**Cambridge
Crossing**

| Parcel G

LAB BUILDING - DESIGN REVIEW REVISIONS

1 GROUND FLOOR ACTIVATION

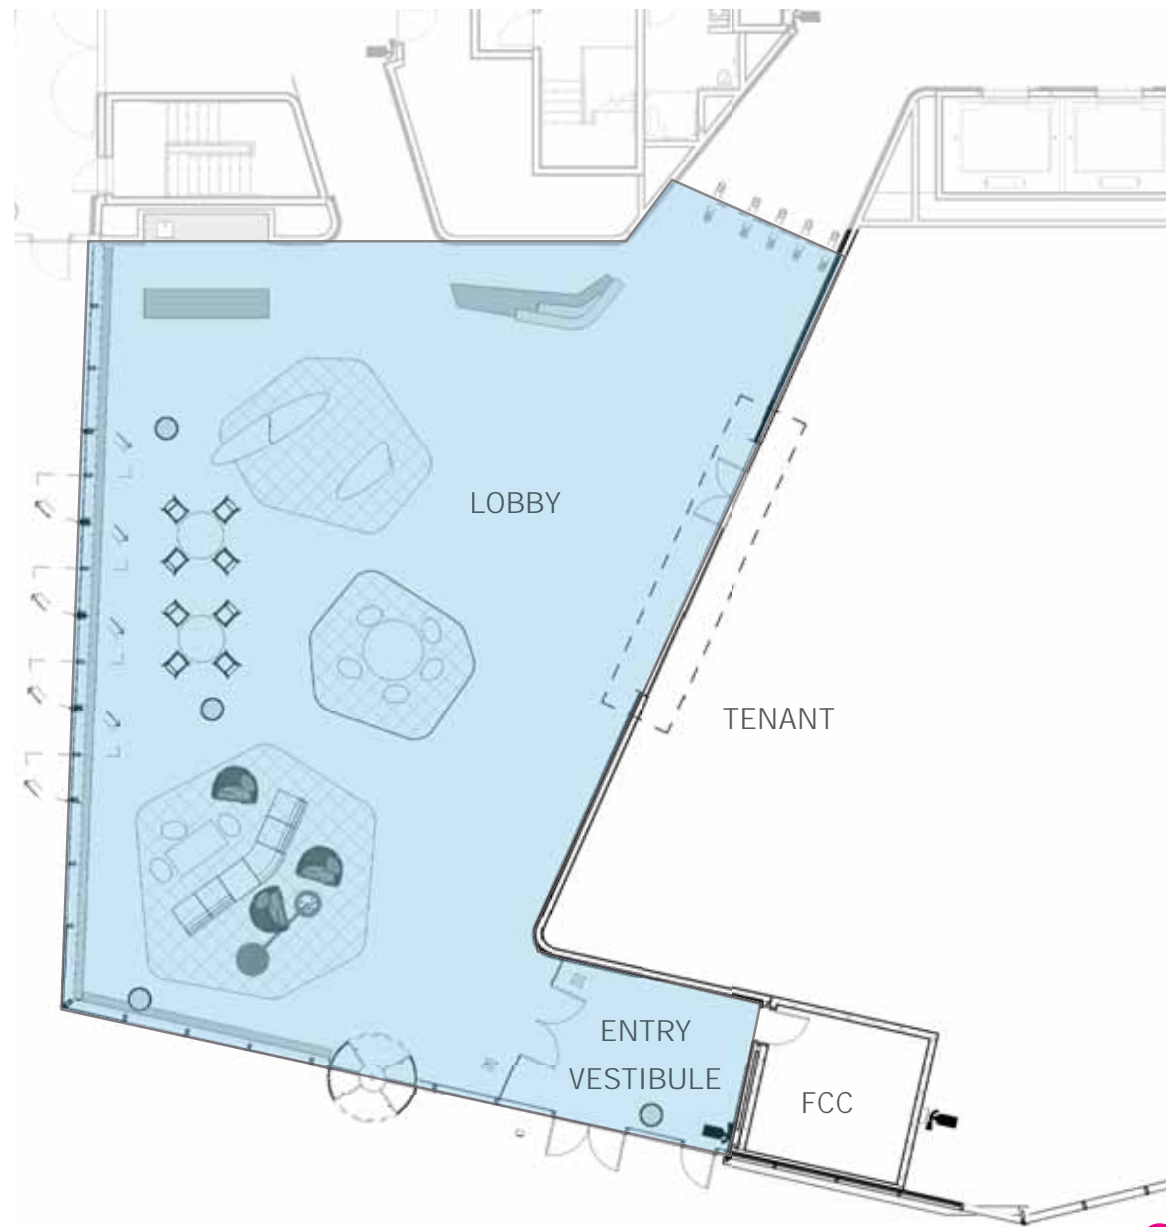
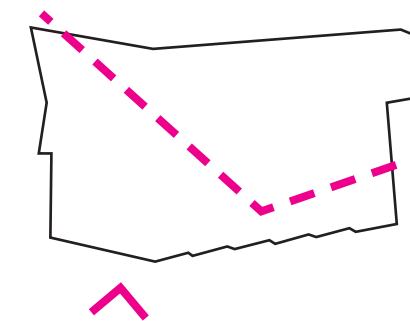
Changes limited to:

- Expand Lobby
- Increased Lobby Frontage

Change limited to :
Increased lobby frontage

① GROUND FLOOR ACTIVATION

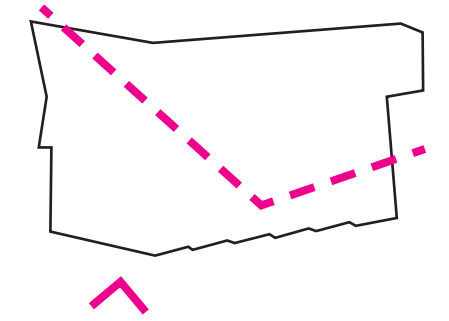
- Expand Lobby
- Increased Lobby Frontage

Change limited to:
Increased lobby frontage

1 EXPAND BUILDING LOBBY

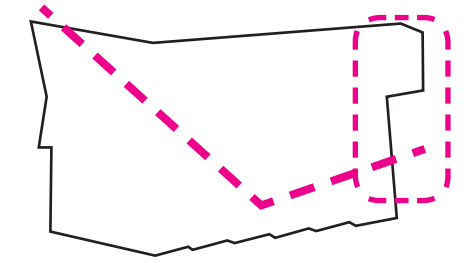
- Expand Lobby
- Increased Lobby Frontage

Change limited to:
Increased lobby frontage

② SCREEN LOADING AND SERVICE YARD

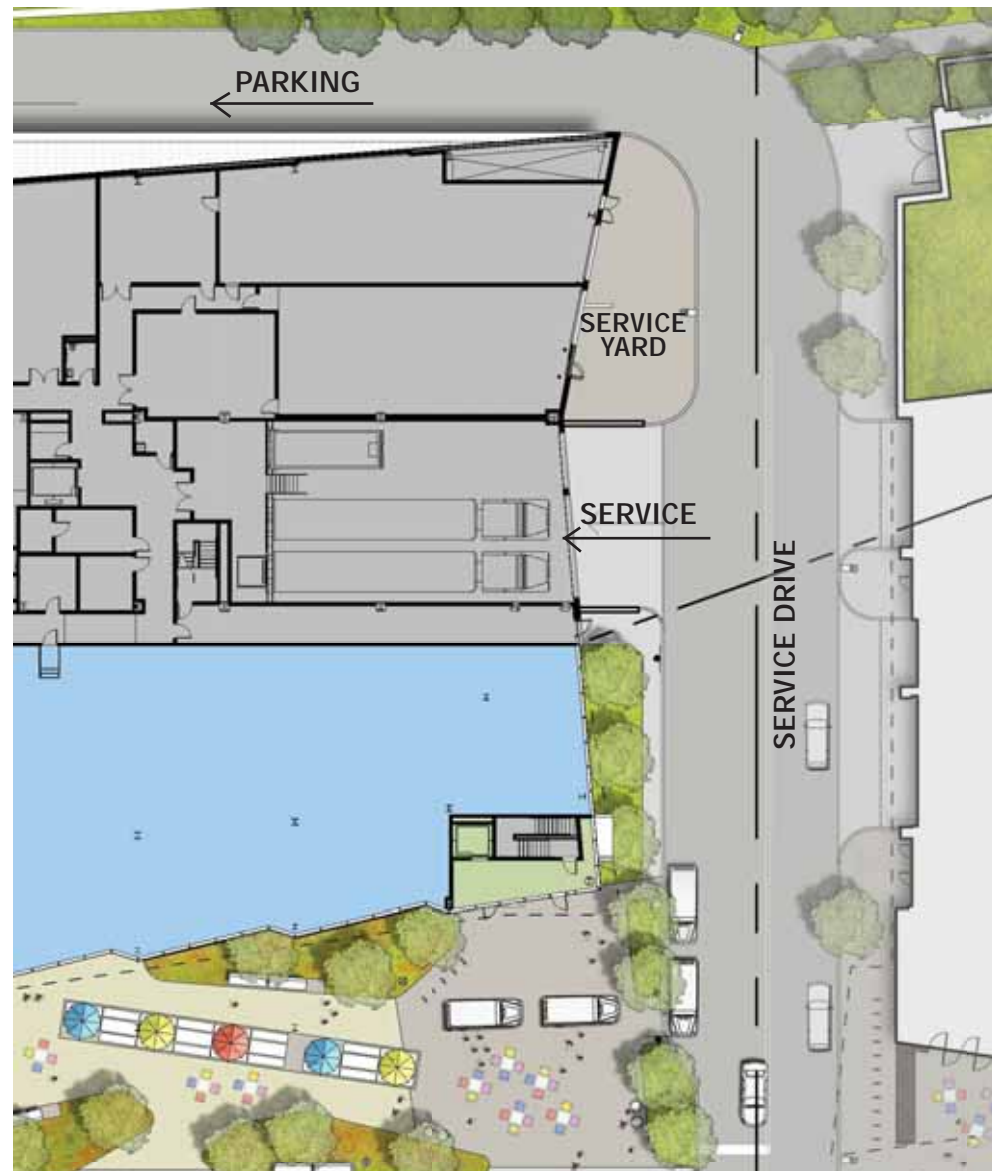
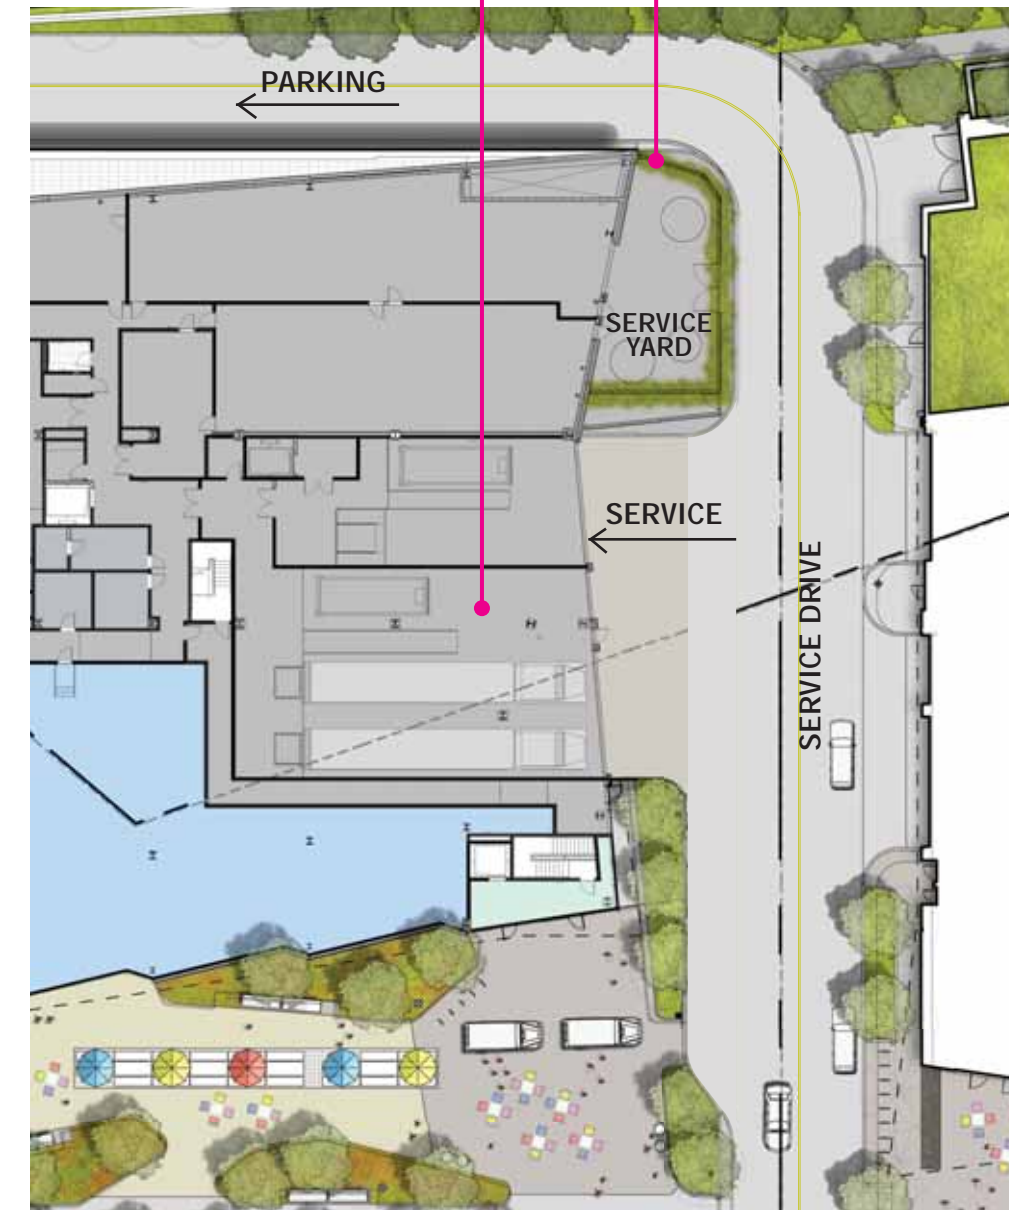
- Added loading
- Screen service yard
- Extend cornice and windows above loading

Changes to limited to:
Added loading
Screen service yard

② LOADING DOCK

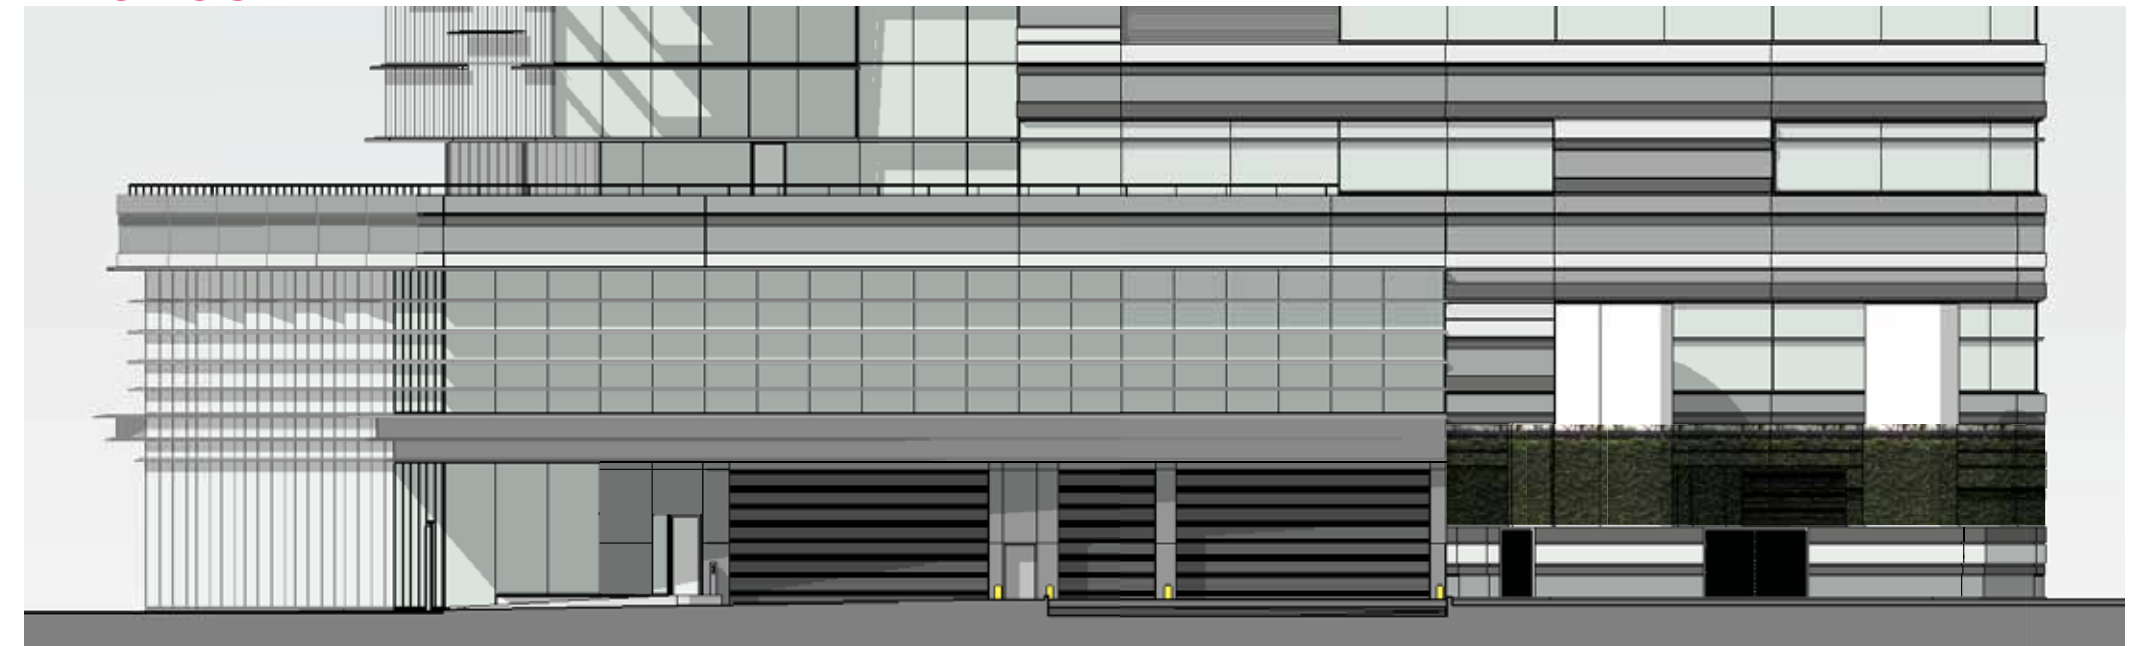
- Added loading
- Extend cornice and windows above loading
- Screen service yard

Changes to limited to:
Added loading
Screen service yard
Extend cornice and windows above loading

② SCREEN LOADING AND SERVICE YARD

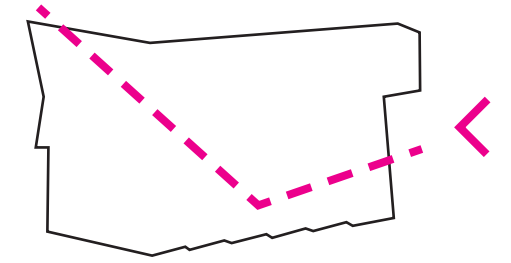
- Added loading
- Screen service yard
- Extend cornice and windows above loading

Changes limited to:
Added loading
Screen service yard
Extend cornice and windows above loading

③ ADD MECHANICAL LOUVER

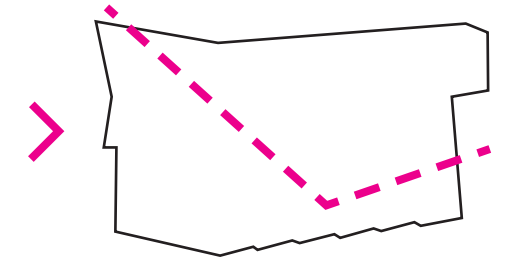
Changes limited to :
Adding louvers
Screening service yard

④ RAISE SOUTH PARAPET - APPROVED

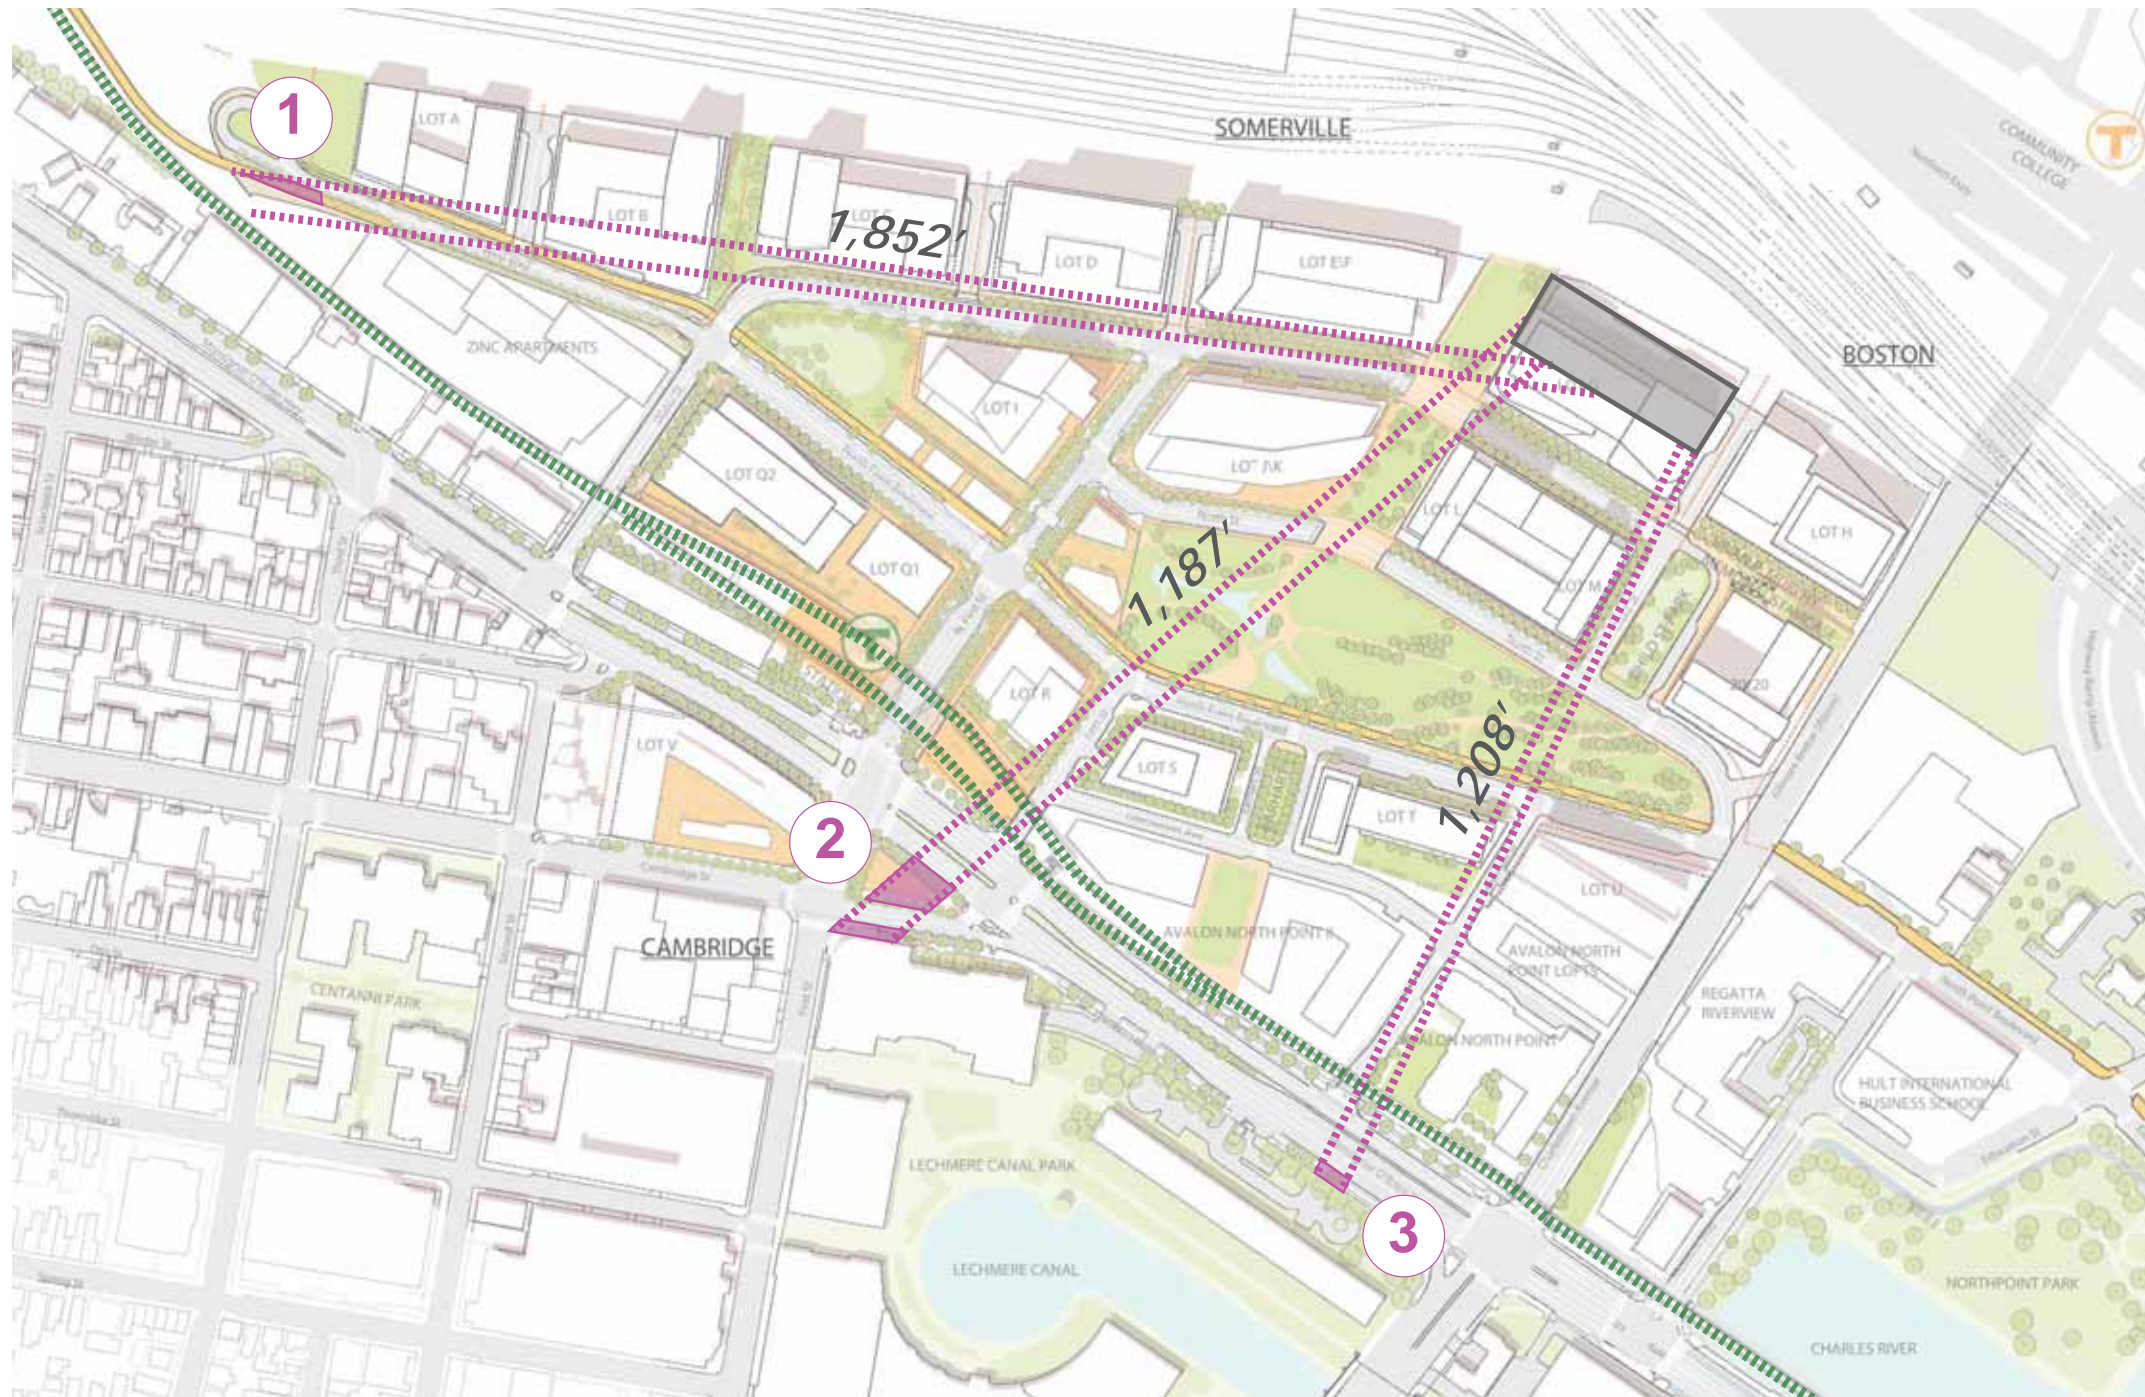
- Raise south parapet 4'-6" to screen added equipment
- Height of north parapet unchanged
- Equipment not visible from grade

Approved design included equipment visible from grade in pink areas (no longer visible in Proposed condition)
